Work Plan Supplement

Remedial Investigation/ Feasibility Study

Crab Orchard National Wildlife Refuge

December 1985

ATTACHMENT S-1

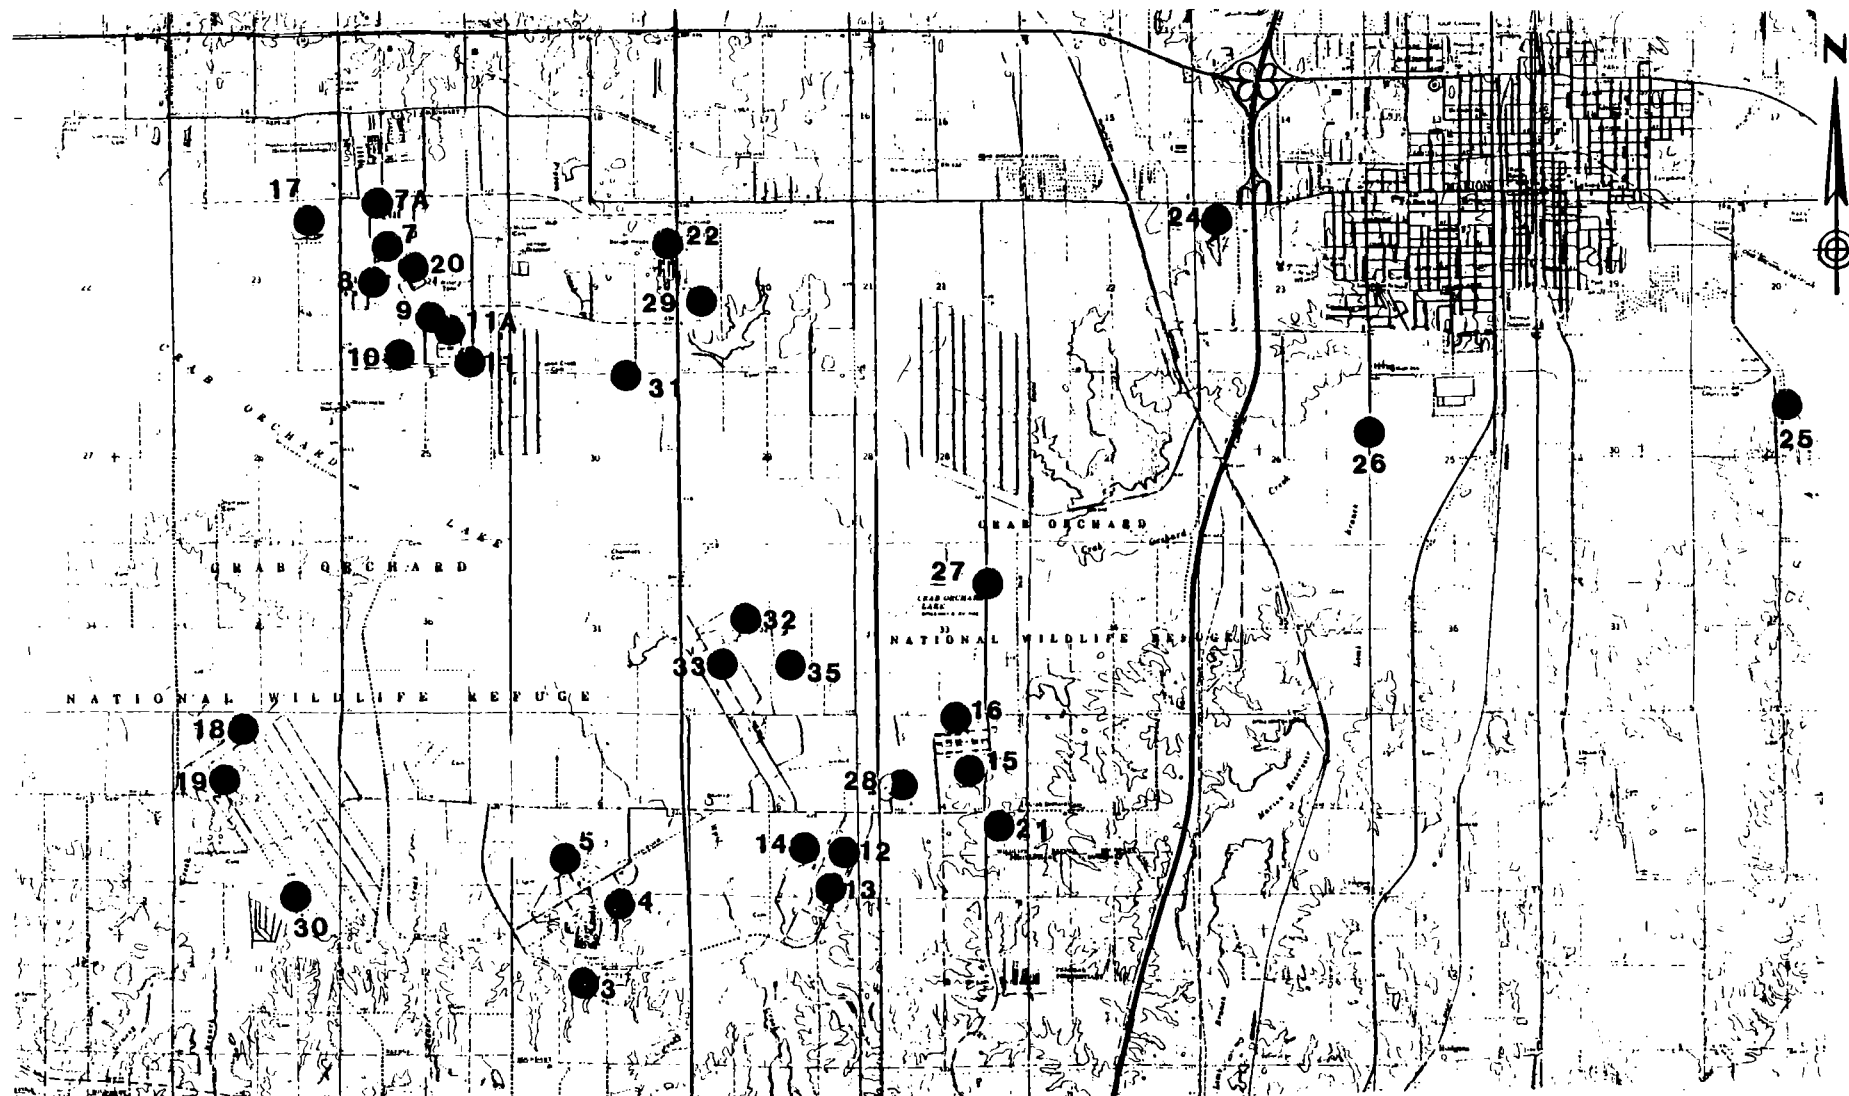
Figure 1 of the Original Work Plan is amended by substituting Attachment S-1. Sampling Site 8 was omitted from the earlier figure and has now been added. In addition, the new Site 35 (see page 5 of the July 31, 1985 Status Report) has been added to Attachment S-1.
